Date: January 16, 2007

To: T10 Committee (SCSI)

From: George Penokie (IBM)

Subject: SAS-2: SAM-4: Miscellaneous State Machine Fixes

Figure 1 — SL (link layer for SAS phys) state machines (part 1)

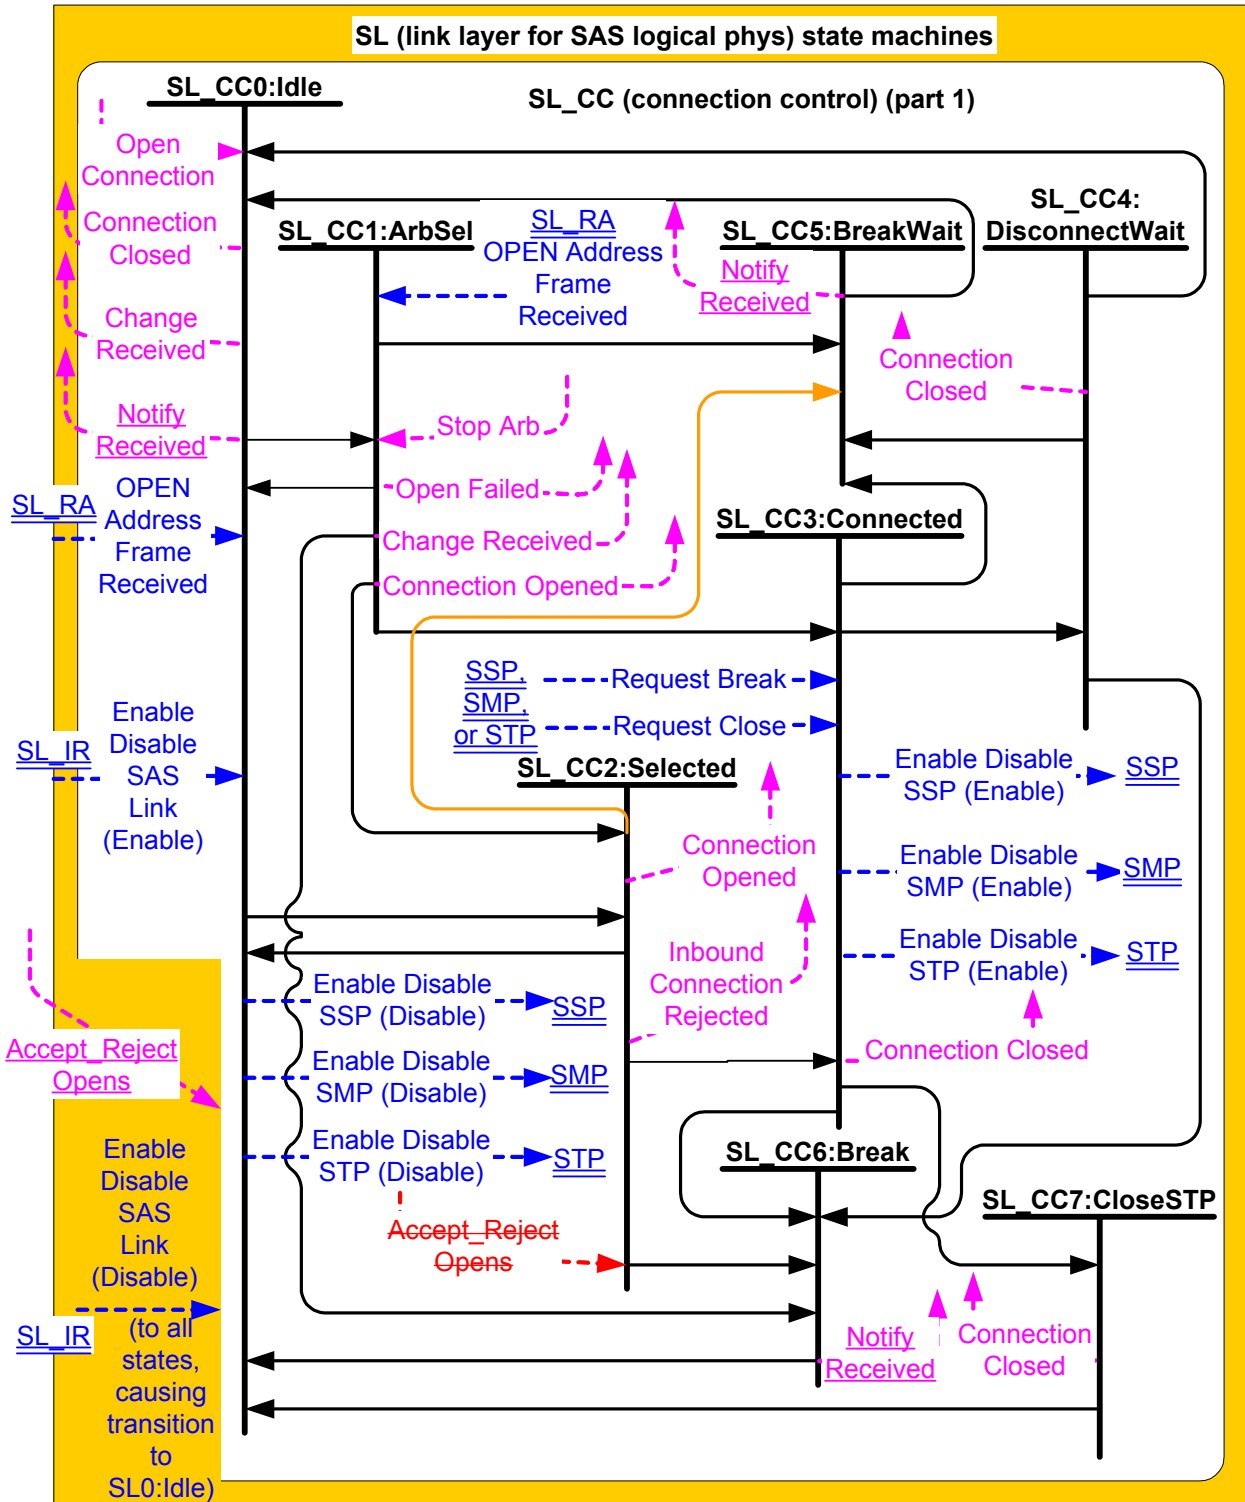
Editor's Note 3: Figure 1 has changed. The changes are indicated by the orange arrow and by underlines on the confirmations, requests, and messages.

Figure 2 — SL (link layer for SAS phys) state machines (part 2)

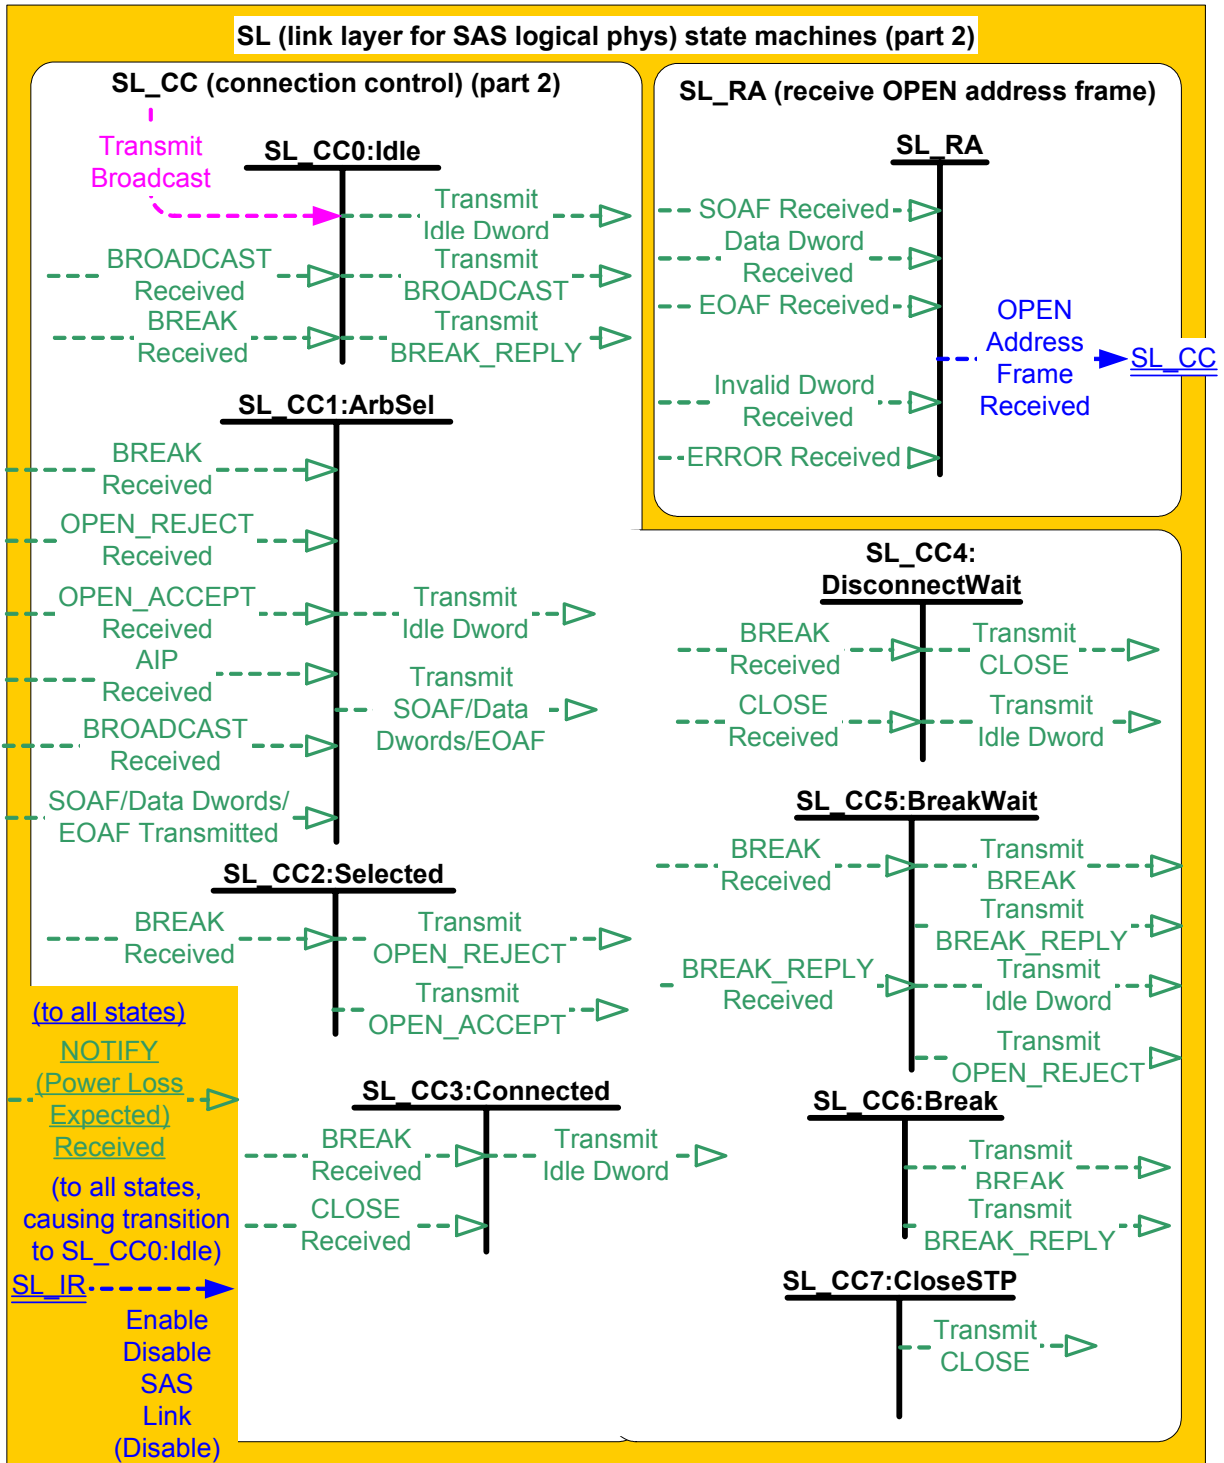
Editor's Note 4: Figure 2 has changed. The changes are indicated by underlines on the confirmations, requests, and messages.

Figure 4 — SSP (link layer for SSP phys) state machines (part 2 - frame reception)

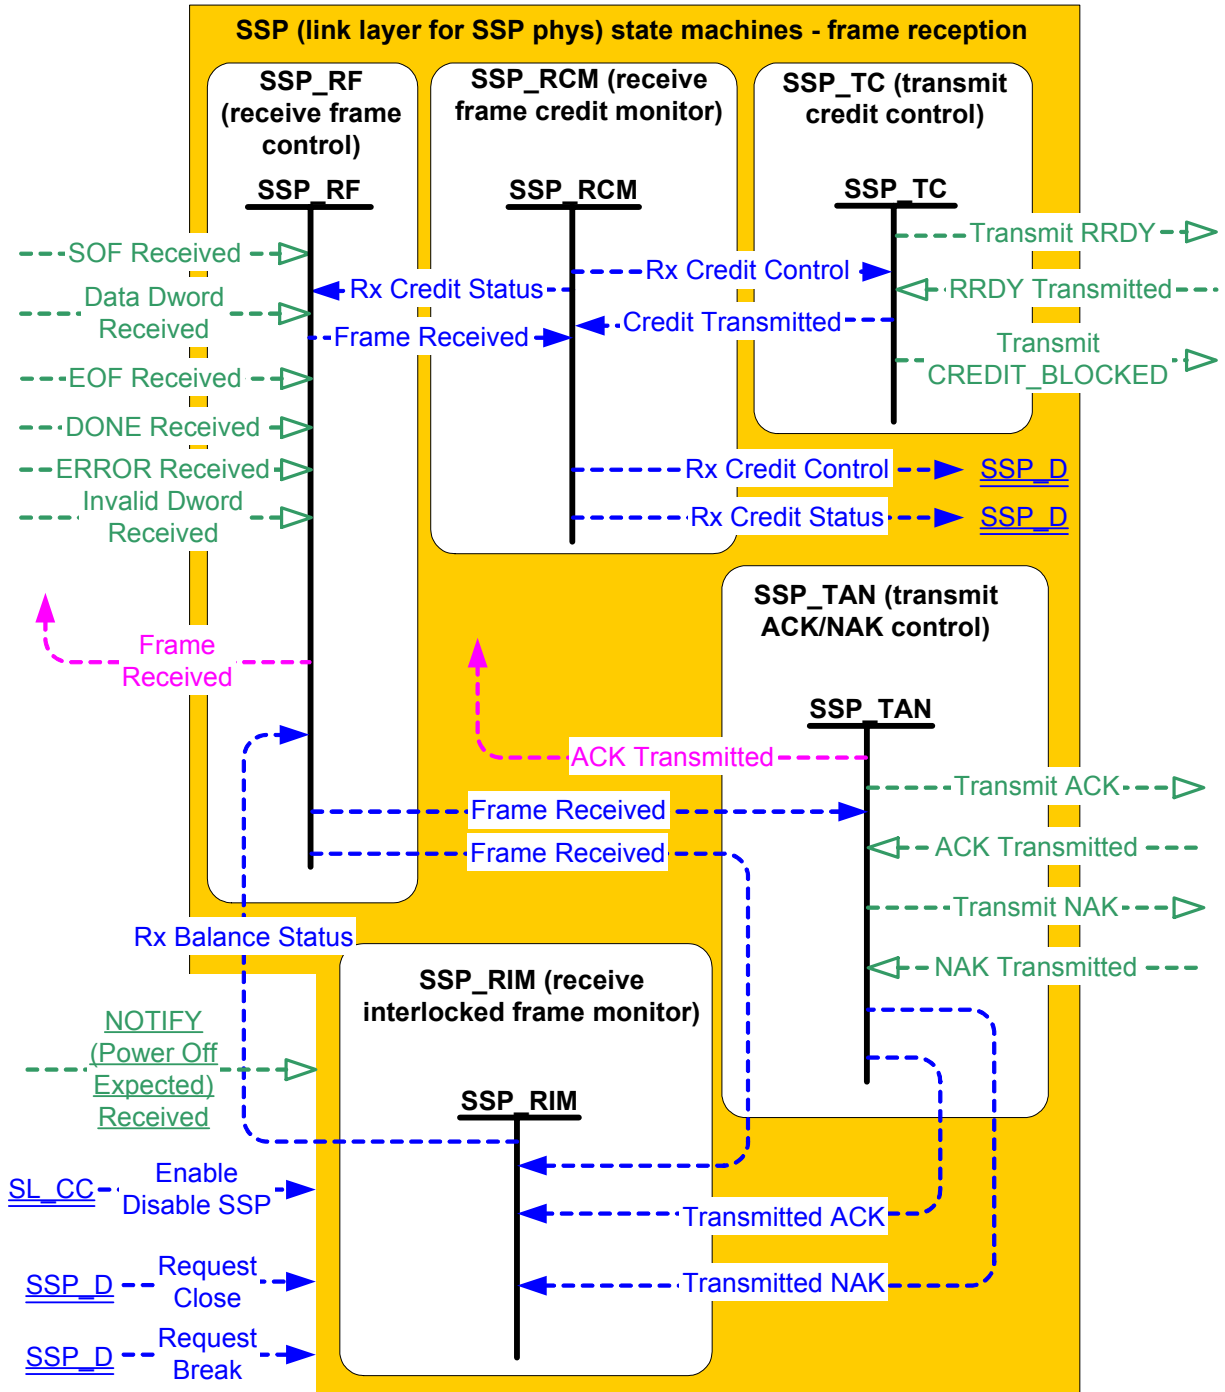
Editor's Note 5: Figure 4 has changed. The changes are indicated by underlines on the confirmations, requests, and messages.

Figure 5 — PL_OC (port layer overall control) state machine

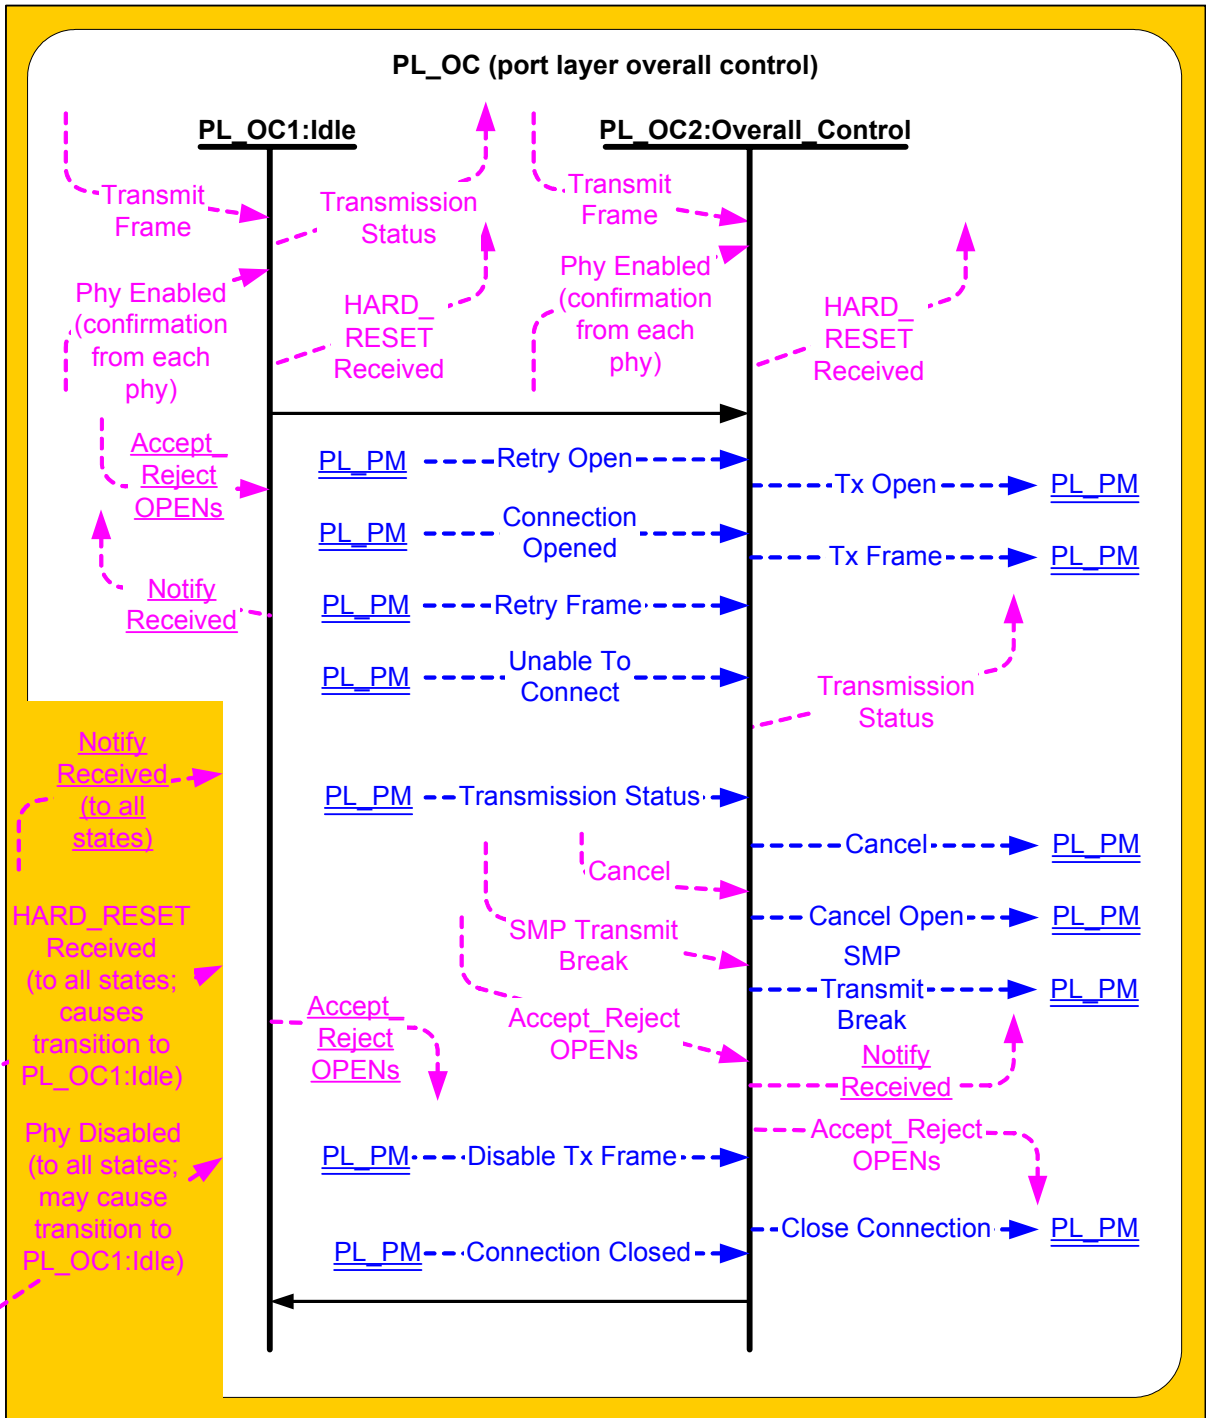
Editor's Note 6: Figure 3 has changed. The changes are indicated by underlines on the confirmations, requests, and messages.

Figure 6 — ST_T (transport layer for SSP target ports) state machines

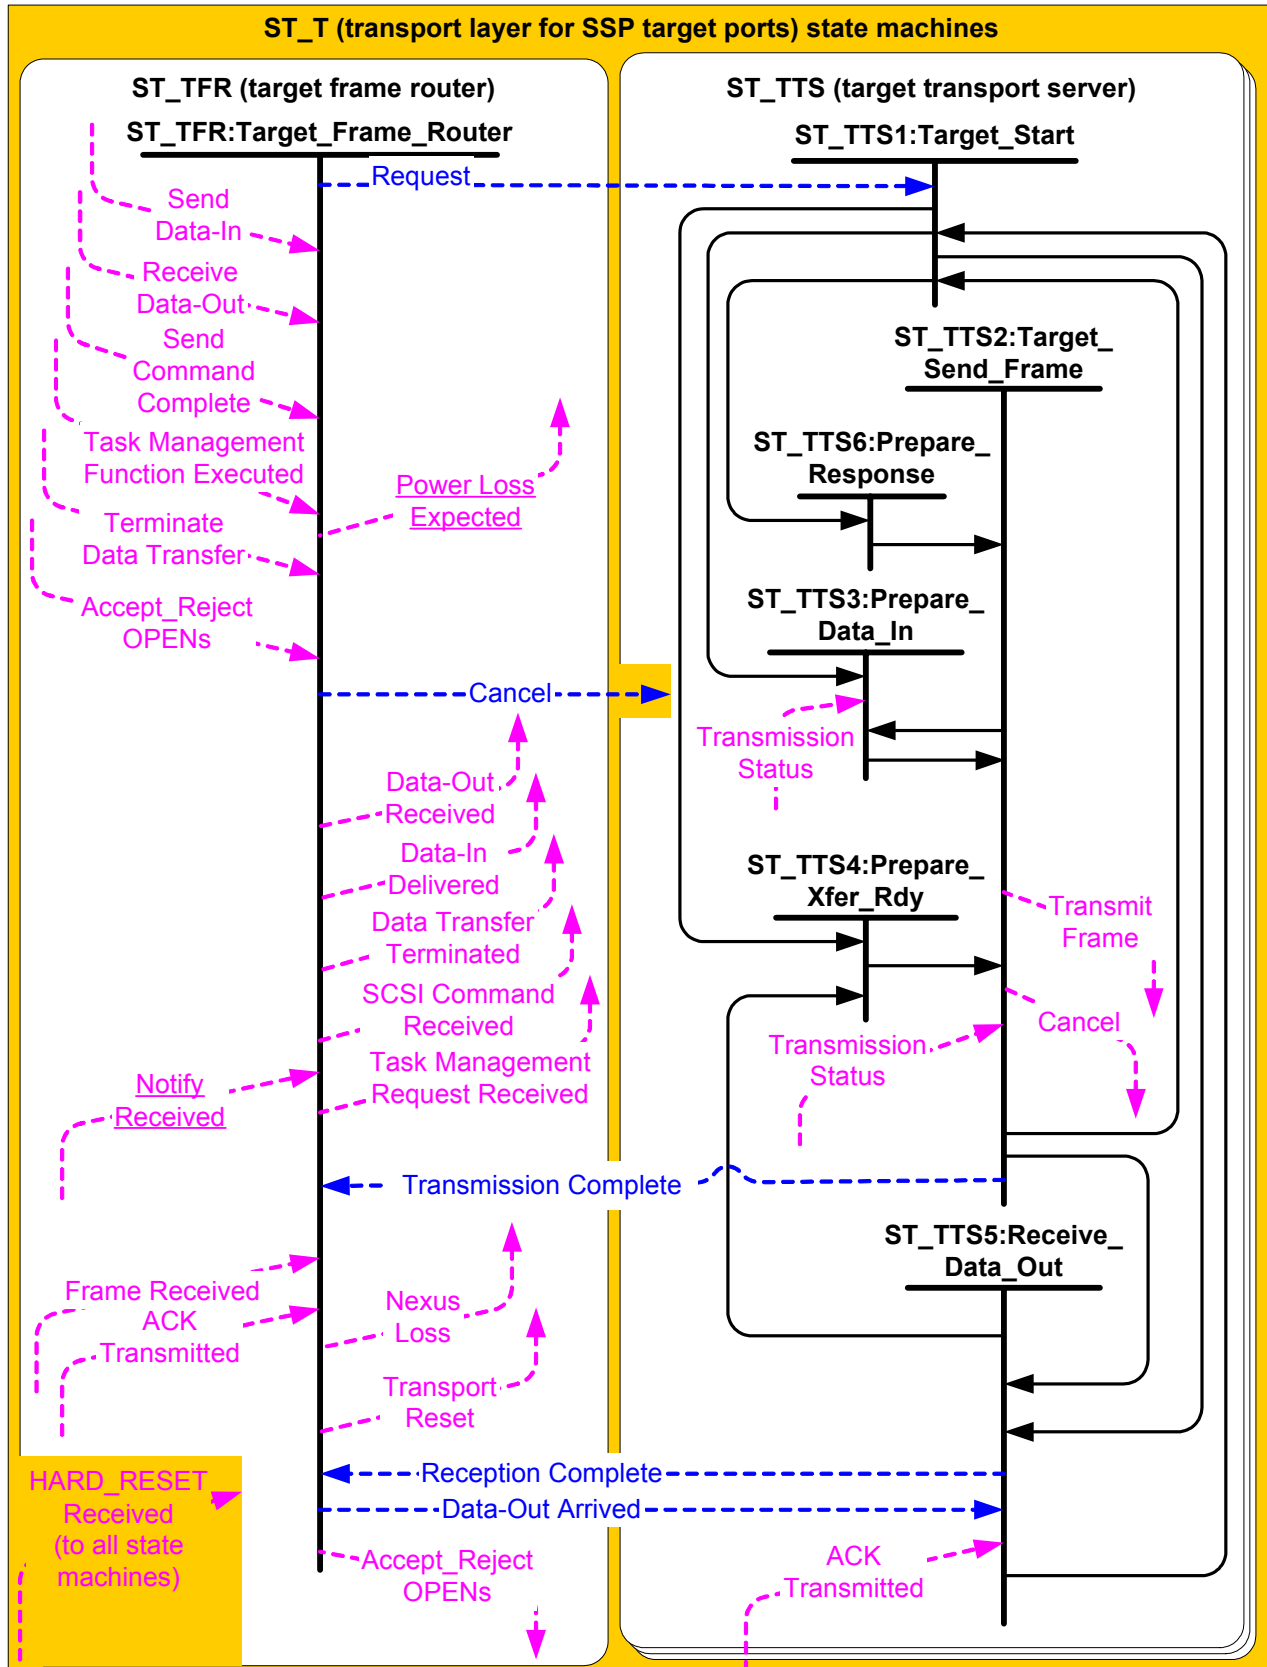
Editor's Note 2: There needs to be a Transmission Status confirmation arrow added to the ST_TTS5: Receive_Data_Out state in the ST_T state machine figure.

Editor's Note 7: Figure 4 has changed. The changes are indicated by underlines on the confirmations, requests, and messages.

Figure 7 — Events and event notifications for SCSI target devices

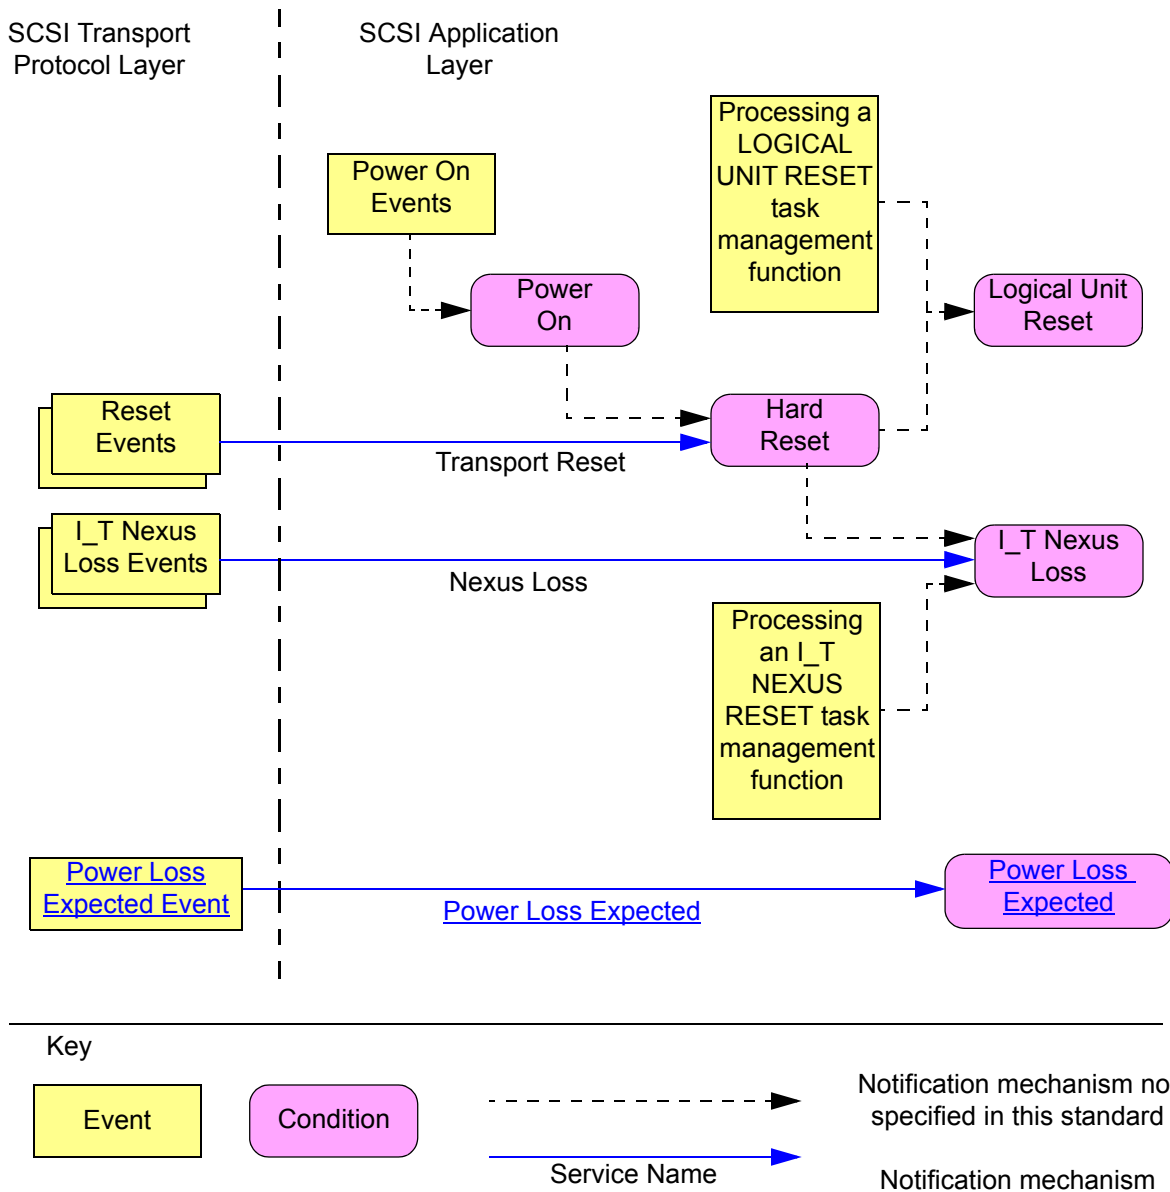
Editor's Note 8: Figure 5 has changed. The changes are indicated by blue underlines.
